**From:** Frank Morabito <[frank@morabitoconsultants.com](mailto:frank@morabitoconsultants.com)>  
**Date:** October 8, 2018 at 2:27:40 PM EDT  
**To:** "Maggie Manrara ([gatormaggie@aol.com](mailto:gatormaggie@aol.com))" <[gatormaggie@aol.com](mailto:gatormaggie@aol.com)>  
**Subject:** CTS - Revised Reports and Estimates

**REMEDIATION OF THE CHAMPLAIN TOWERS CONDOMINIUM**  
**ENGINEER'S ESTIMATE OF THE PROBABLE CONSTRUCTION COST**  
**THOMAS E. HENZ, PE, INC. CONSULTING ENGINEERS**

**Re: Champlain Towers South Condominium  
Structural Field Survey Report  
MC Job# 18217**

Figure E: Deteriorated plywood soffit above entrance drive.

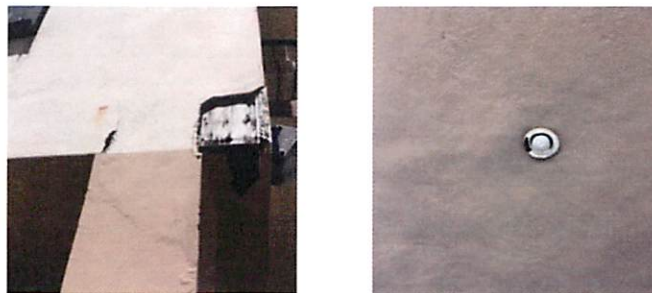
- E. Several areas of the entrance drive soffits under the second floor were observed by MC to have deteriorated black plywood. This condition was also observed at several light fixtures in the entrance soffit. MC could not get access into the soffit areas to observe the extent of the deteriorated soffits and support framing as CTS maintenance was too busy to assist us. MC is concerned that mold exists above these soffit areas and the soffit support framing is deteriorated which will require the complete removal and replacement of the entrance suspended soffit. Further investigation into this area is warranted.

Figure G: Typical cracking in the stucco exterior facade.

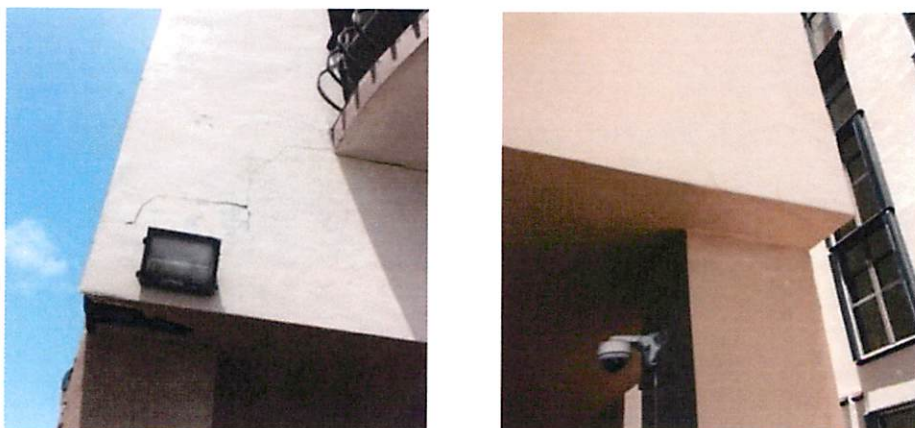
- G. Significant cracking in the stucco exterior façade often occurs at the mortar bed joint between the top of the concrete floor slab and first block masonry course. Although MC does not see this crack as a source of water infiltration into the condominium units, such cracks need to be routed and repointed to prevent future water permeation. All significant façade stucco cracking is to be repaired in accordance with the recommendations of ICRI.

Figure K1: Previously installed failed injection repairs with leaching forming

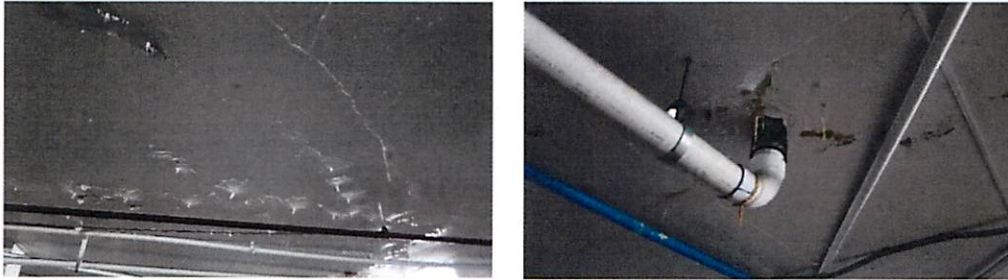
- K. MC visual observations revealed that many of the previous garage concrete repairs are failing resulting in additional concrete cracking, spalling and leaching of calcium carbonate deposits. At the underside of Entrance/Pool deck where the slab had been epoxy-injected, new cracks were radiating from the originally repaired cracks. The installed epoxy is not continuous as observed from the bottom of the slab, which is evidence of poor workmanship performed by the previous contractor. The injection ports were not removed, and the surfaces were not ground smooth at the completion of the injection. Leaching of calcium carbonate deposits in numerous areas has surely caused CTS to pay to repaint numerous cars. This leaching will continue to increase until proper repairs are completed. MC is convinced that the previously installed epoxy injection repairs were ineffective in properly repairing the existing cracked and spalled concrete

slabs. MC recommends that the Entrance/Pool deck concrete slabs that are showing distress be removed and replaced in their entirety. Unfortunately, all of these failed slab areas are under brick pavers, decorative stamped concrete and planters which require completed waterproofing replacement. All repaired concrete slabs located in the parking garage are to be repaired in accordance with the recommendations of ICRI.
